### **Bristol Airport Planning Inquiry**

We write regarding the Planning Inquiry for proposed expansion of Bristol Airport, and specifically responding to your questions regarding the recommended planning condition (50) relating to improvements at the A38 Edithmead Roundabout.

### Planning condition (50)

Figure 3.1: Passenger growth analysis of Junction 22

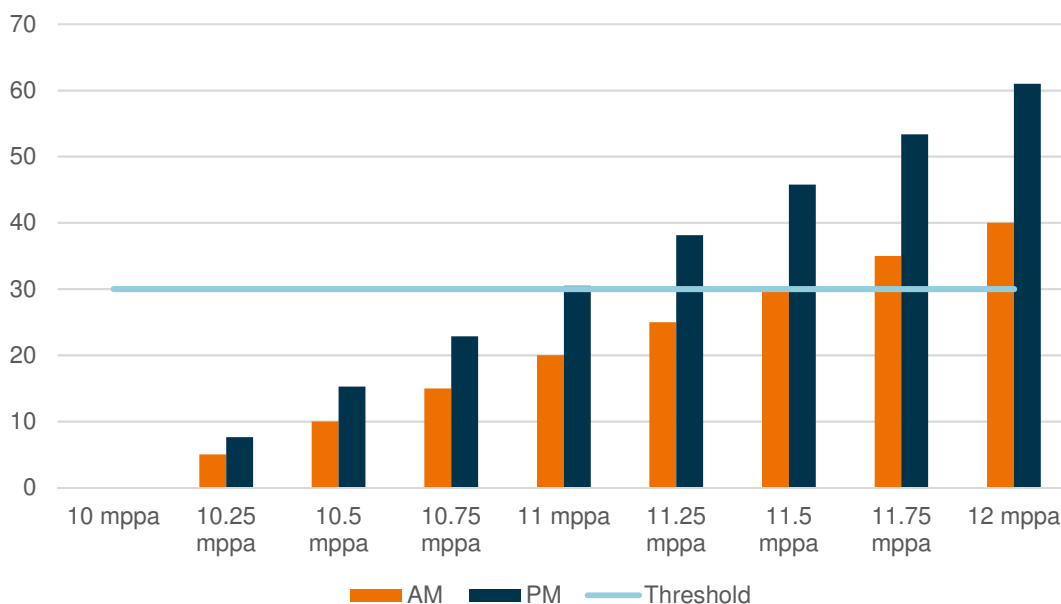
- 3.3. The 30 two-way vehicle level is reached at 10.984mppa in the PM peak. It is therefore proposed that a threshold level of 11 mppa is set before mitigation is required to be in place at Junction 22.

Figure 3: 2032 With LP Development – AM Peak Period (100m gridlines)

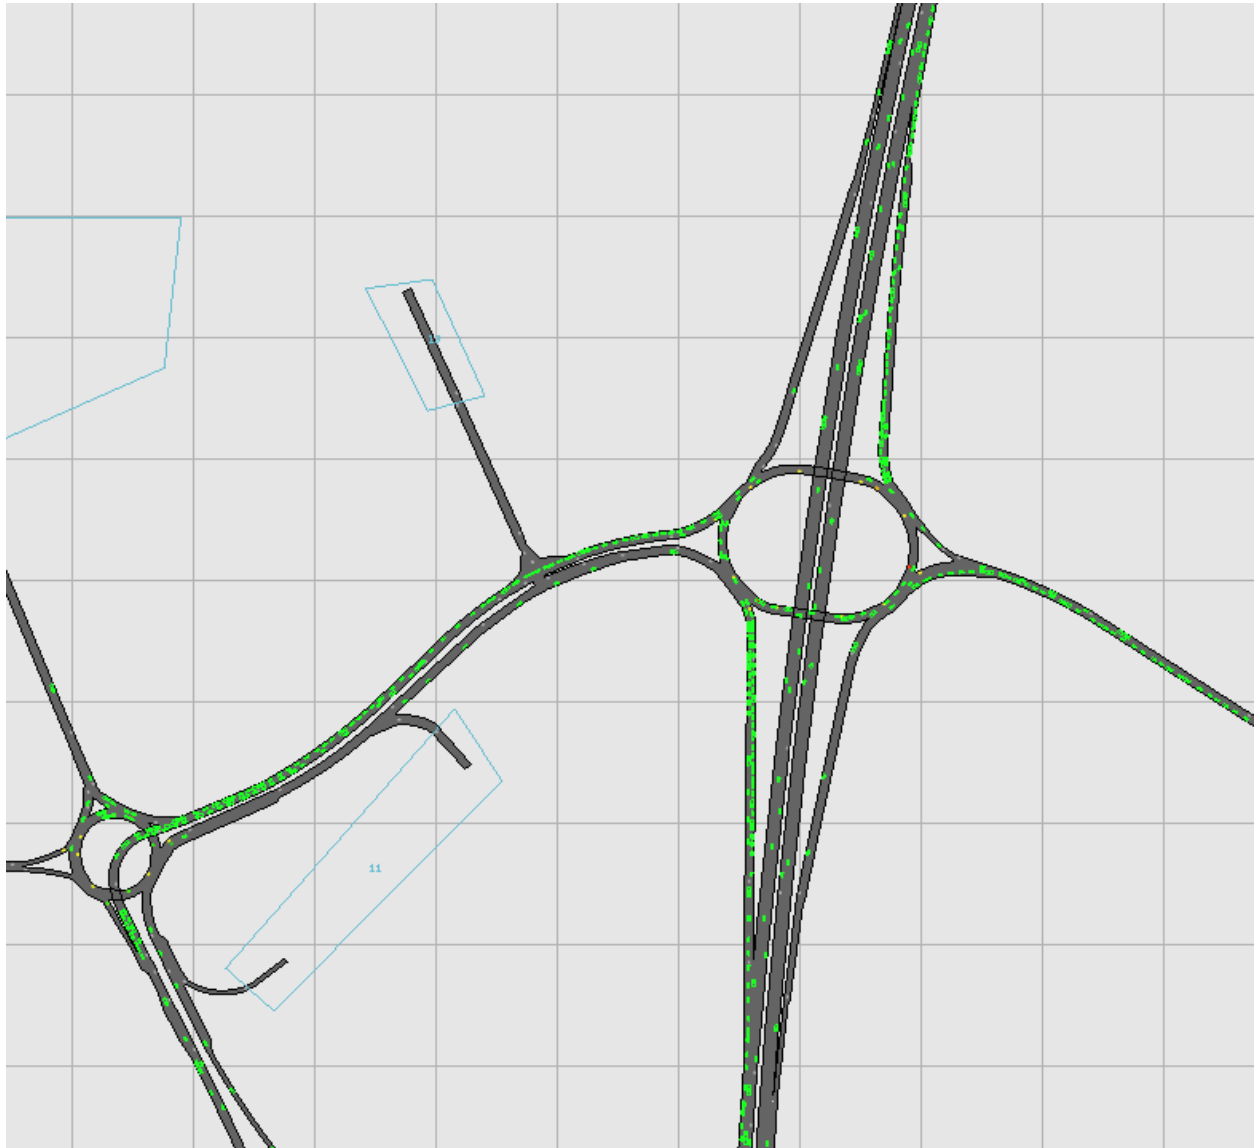
The queues that form at Junction 23 in both the AM and PM periods in the With LP Development scenario are sufficient to extend back onto the M5 main carriageway and impede its operation. This includes stationary vehicles being present on the M5 main carriageway.

Figure 5: Proposed Indicative Mitigation at Junction 22 (100m gridlines)

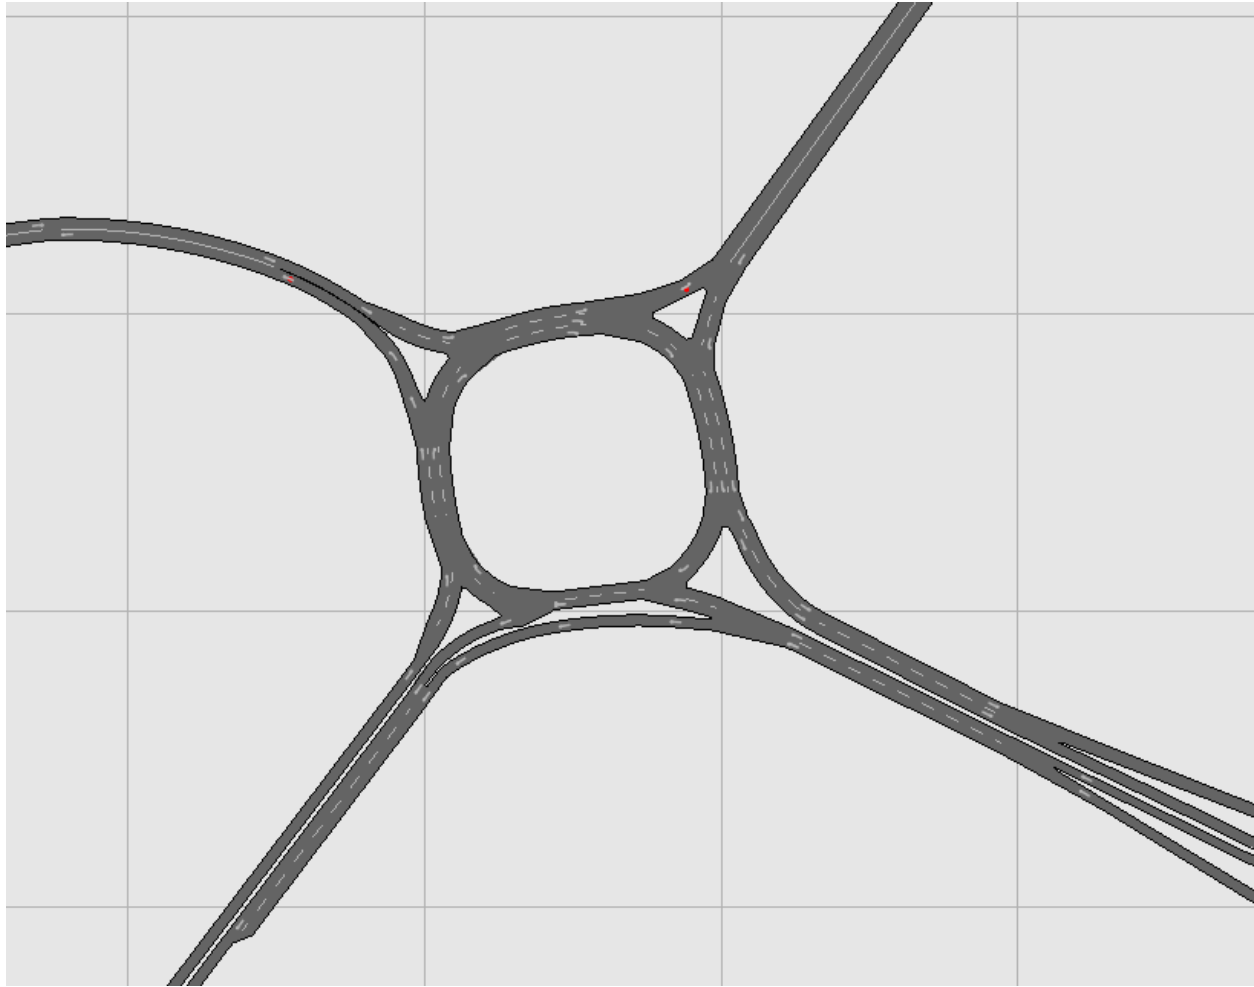
Both options remove the queue on the northbound off-slip in the PM period. In general, the options operate without excess delay or queuing. However, within the signal option, the reallocation of priority does cause increased queuing and delay on the local road network. A queue of several hundred metres forms on the A38 northbound approach to the junction.

Therefore, both of the indicative options would provide sufficient capacity for the SRN to safely accommodate the LP.

Figure 6: Proposed Indicative Mitigation at Junction 23 (100m gridlines)

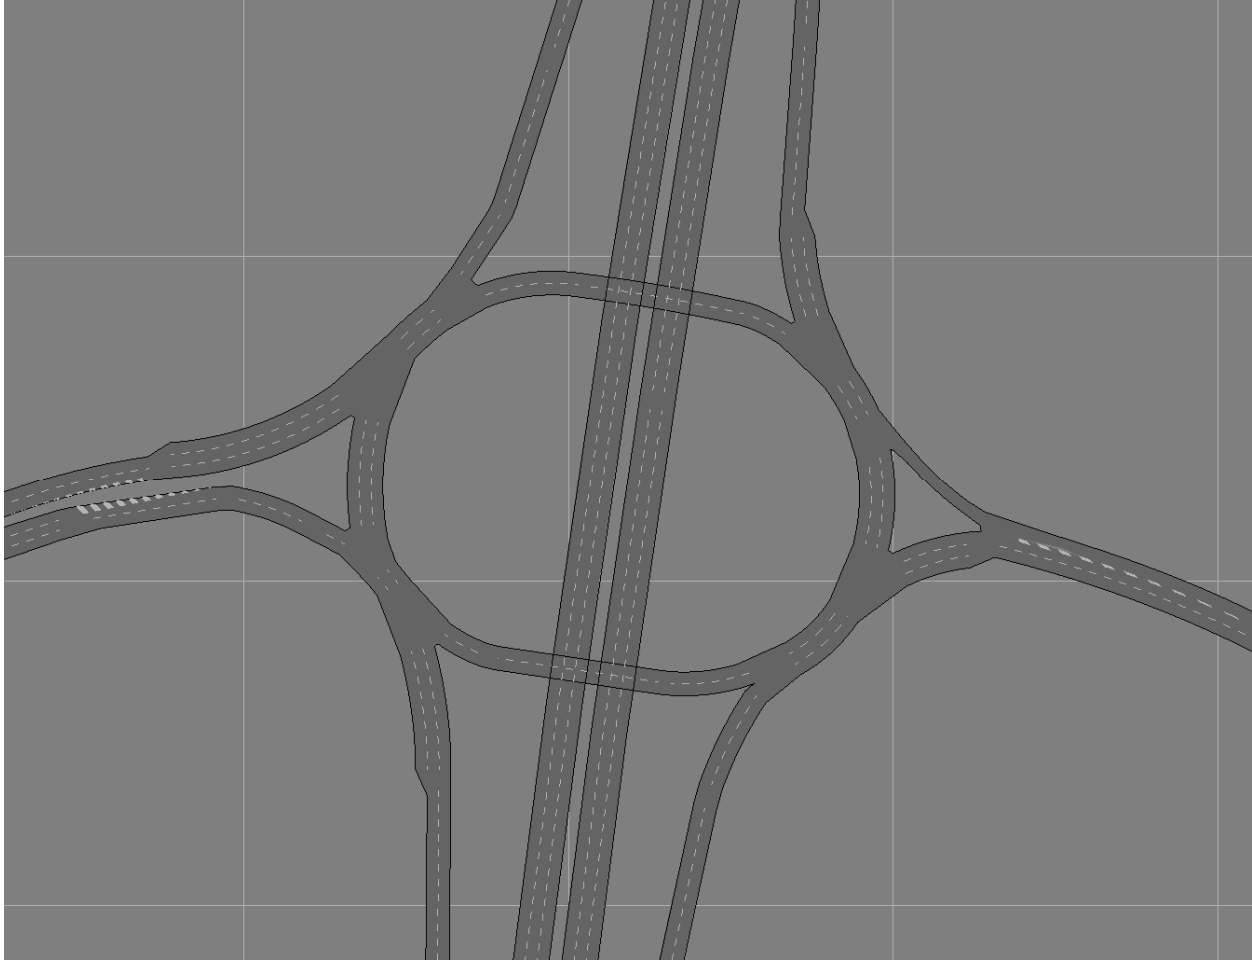
With the mitigation measures at junction 23 in place, the queues on the slip-roads do not extend back to the M5 mainline. The junction generally operates efficiently, with the majority of queues clearing during the green phase of the signals. The queue on the western arm is no longer of sufficient length to block back to the Dunball roundabout and impede its operation, as it does in the committed highway network.

As can be seen from Figure 6, the model doesn't include side road access points such as at Puriton onto the A39. The operation of these junctions and any interaction with Junction 23 would need to be assessed through the development management process.

Figure 2: Maximum Queue Length (with 95% confidence intervals) at the Edithmead Roundabout eastern arm (2023 Weekday PM Period)

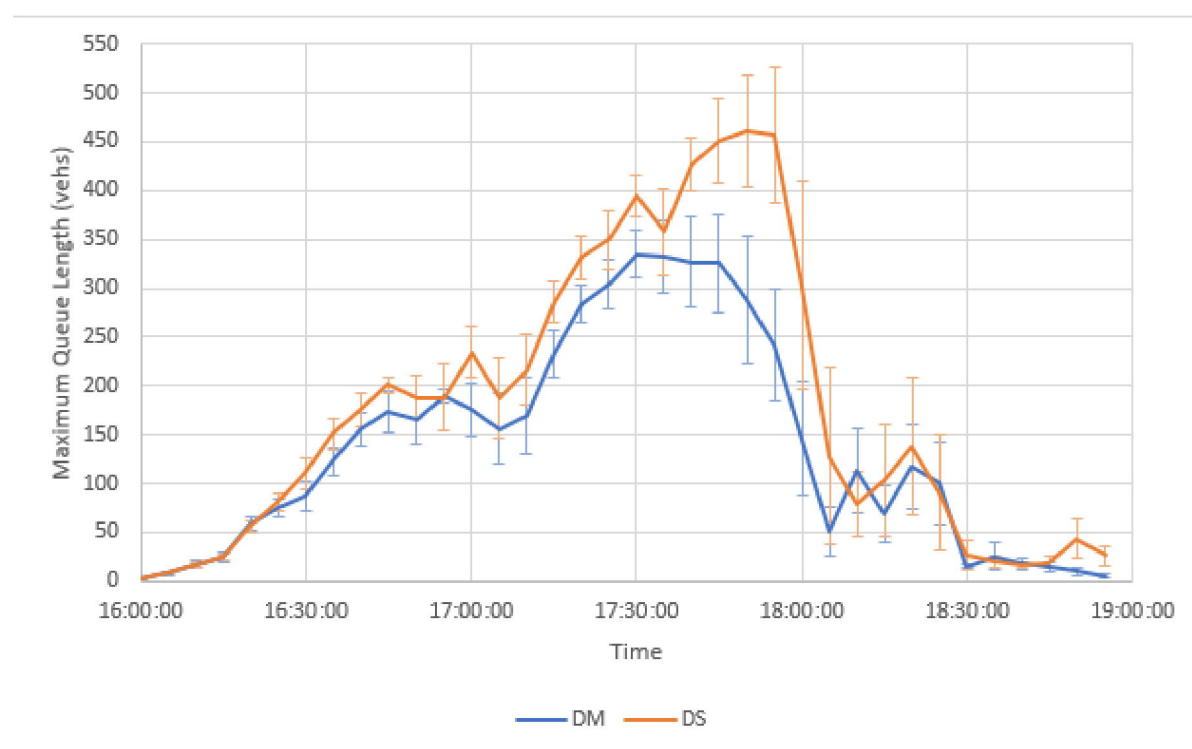
Figure 2 shows modelled queue lengths on the eastern arm of the Edithmead roundabout, where the queue extends onto the M5 northbound carriageway. On the M5 carriageway, the queue is rolling in nature and sporadically blocks through traffic travelling northbound in lane 1. Therefore, the queue length can display high levels of variation. The data in Figure 2 illustrates that modelled queue lengths in the do-something scenario are up to around 100 vehicles longer than in the do-minimum scenario. Therefore, the addition of development trips exacerbates the existing capacity and safety problems on the M5 northbound carriageway at Junction 22.

The results of the Highways England M5 J22 and J23 Paramics modelling work demonstrated that relatively low increases in flow resulting from development proposals in the vicinity of M5 J22 and the A38 Edithmead roundabout can lead to significant increases in queuing on the northbound off-slip of the M5 J22 during the PM peak period. Therefore, we considered, without mitigation, that the impact of the full quantum of development at Isleport Lane would result in an unacceptable safety impact on the basis that there is an increased potential for vehicular conflict to occur on the high-speed network at M5 J22. As such we recommended a planning condition that restricted the occupation of any dwellings on site until the identified improvement at A38 Edithmead roundabout/J22 of the M5 was implemented and open to traffic.
